Report to the Future Melbourne (Planning) Committee

**Ministerial Referral: TPM-2015-16 - Commercial Building (C1)
2-42 Aurora Lane, Docklands**

1 December 2015

PLANNING REPORT - MINISTERIAL REFERRAL

FIGURE 8: CROSS SECTIONS DETAILING THE PROPOSED NORTH-SOUTH CONNECTOR LANE

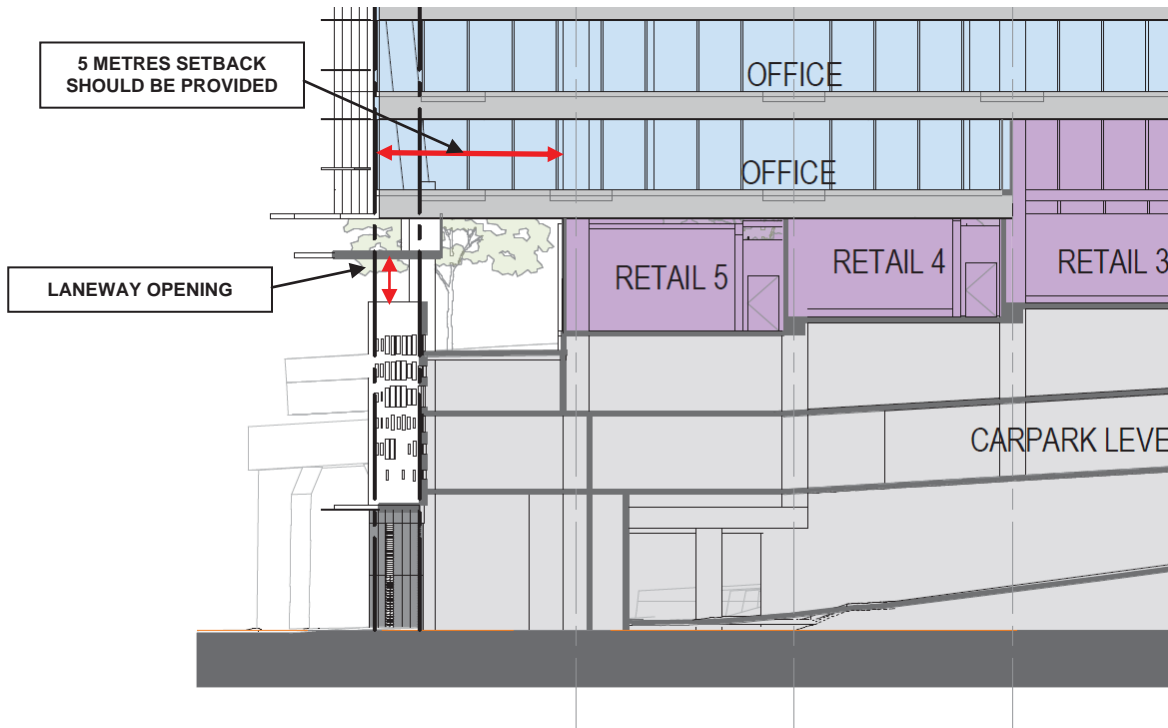
The Development Plan proposes completing the lane with a three to four storey built form along its eastern side, conceived as an active edge screening car parking and services and occupied by strata offices. The construction of Building C1 is the first stage of this vision. The length of the façade to Aurora Lane is approximately 46 metres long and 71 metres high (16 storeys). The height of building C1 directly abutting Aurora Lane is significantly out of scale with the existing site context and provides no transition to the more intimate scale of buildings on the opposite side of Aurora Lane, included the Heritage Listed Goods Shed. It is recommended that the building retain a 5.0 metres setback above the ground floor plane (level 3) from Aurora Lane to ensure that the proposed development maintains the intimate pedestrian laneway scale as envisioned in the development plan.

Importantly, the setback from Aurora Lane will also allow the north-south laneway (connecting Collins Street to Aurora Lane) to be open to the sky, rather than a long internal corridor enclosed on three and a half sides. The corridor as detailed in Figure 8 below is approximately 46 metres long and features a limited 1.0 metre opening to the west. The current arrangement provides for limited legibility and fails to ensure that safety, and perceptions of safety, are maximised in public spaces

FIGURE 9: LIFT LOBBY ACCESS VIA MARKET PLACE LANE

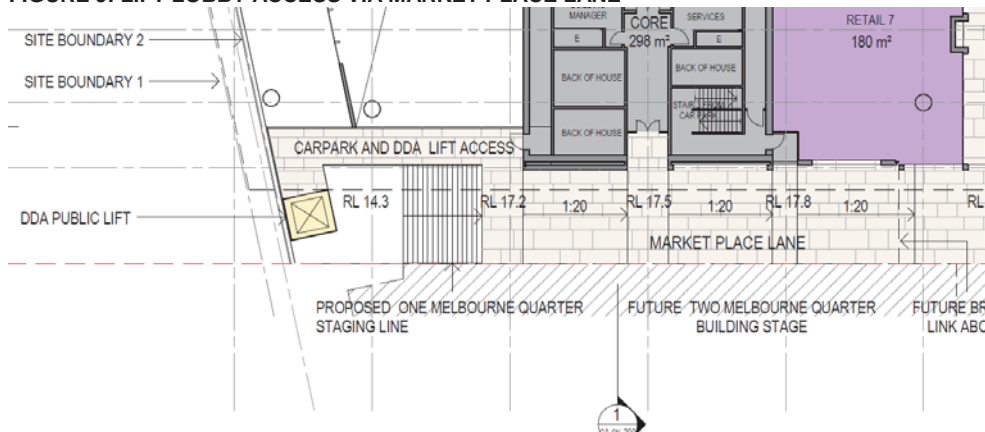
There is no doubt that the proposal will significantly improve accessibility for the broader community by providing a pedestrian link from Aurora Lane to Collins Street, where no access currently exists. However, the lift location creates an awkward lift entry space that appears to be unsafe and disconnected from Marketplace Lane (refer Figure 8) and fails to ensure that safety, and perceptions of safety, are maximised in public spaces.

This matter was raised in pre-application meetings, where it was noted that the public lift should be a dominant feature along Aurora Lane to ensure a high level of pedestrian attraction and public safety is achieved.

The proposed lift location therefore fails to provide an appropriate design response to CPTED (Crime Prevention Through Environmental Design) principals and lacks a pedestrian focus.

It is considered that the design and location of the lift should be amended to better respond to Marketplace Lane and to remove the entrance alcoves at the top and bottom of the lift, which should accord with Safer Design and CPTED principles.

FIGURE 9: LIFT LOCATION ON NORTH-SOUTH CONNECTION

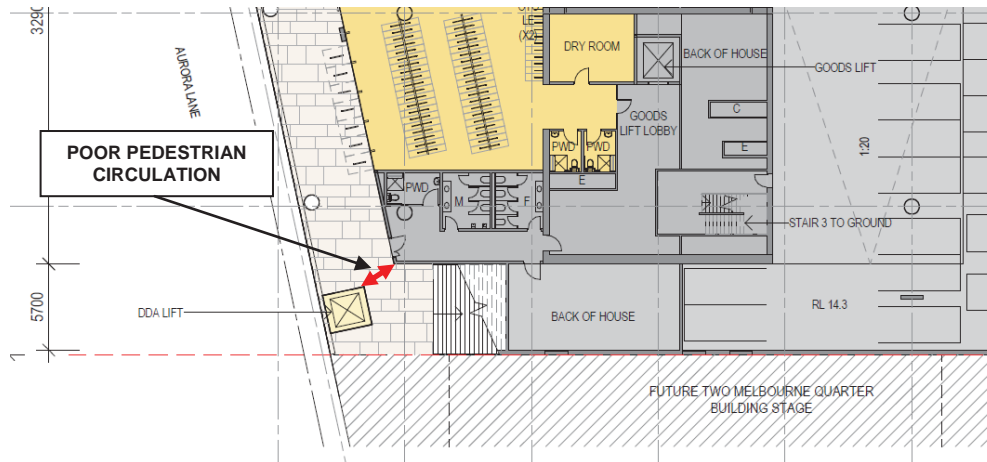
Similarly, proposed lift location at mid-level appears ill-conceived and also results in a pinch point for pedestrians of the North-south connection between Collins Street and Wurundjeri Steps and lacks the public surveillance required of a main pedestrian thoroughfare, as detailed in figure 10 below. It is recommended that the lifts location be incorporated in the the design of the building rather than appearing as a later addition.

FIGURE 10: PROPOSED SKY PARK ILLUSTRATION

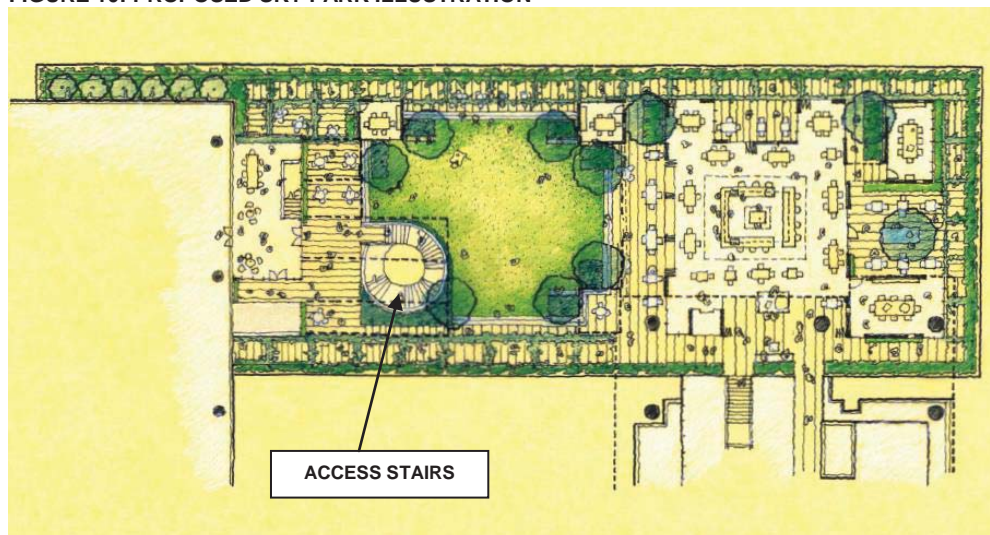
A further issue identified by Council Urban Design Department is the accessibility to the proposed sky garden. Whilst the proposed sky garden provides a major open space offering for the worker population within the development, its true recreational potential may be compromised by the lack of a direct access from Collins Street and the adjoining commercial uses which would likely seek to trade into this space i.e. restaurants and cafes.

Overall, it is considered that this space should be recognised as public space offering for the broader Docklands community as a whole, and the design should ensure that local residents and workers are welcomed and encouraged to use this space. To this end, it is recommended that a direct connection between the plaza on Collins Street and the sky garden be provided (that is visibly prominent and easily accessible from Collins Street) to ensure that this space is inviting to a broader group of people and users (as depicted in figure 10 below), and not just focused on the occupants of the Melbourne Quarter.

A condition is, therefore, recommended in the decision section of this report seeking amendments to the plans to address the above concerns.

- a) Elevation design details at a scale of 1:50 of the Collins Street ground level frontage.
 - b) The provision of a direct pedestrian connection between the plaza on Collins Street and the sky garden that is visibly prominent and easily accessible from Collins Street (generally in accordance with the illustration provided on page 7 of the Development Plan addendum).
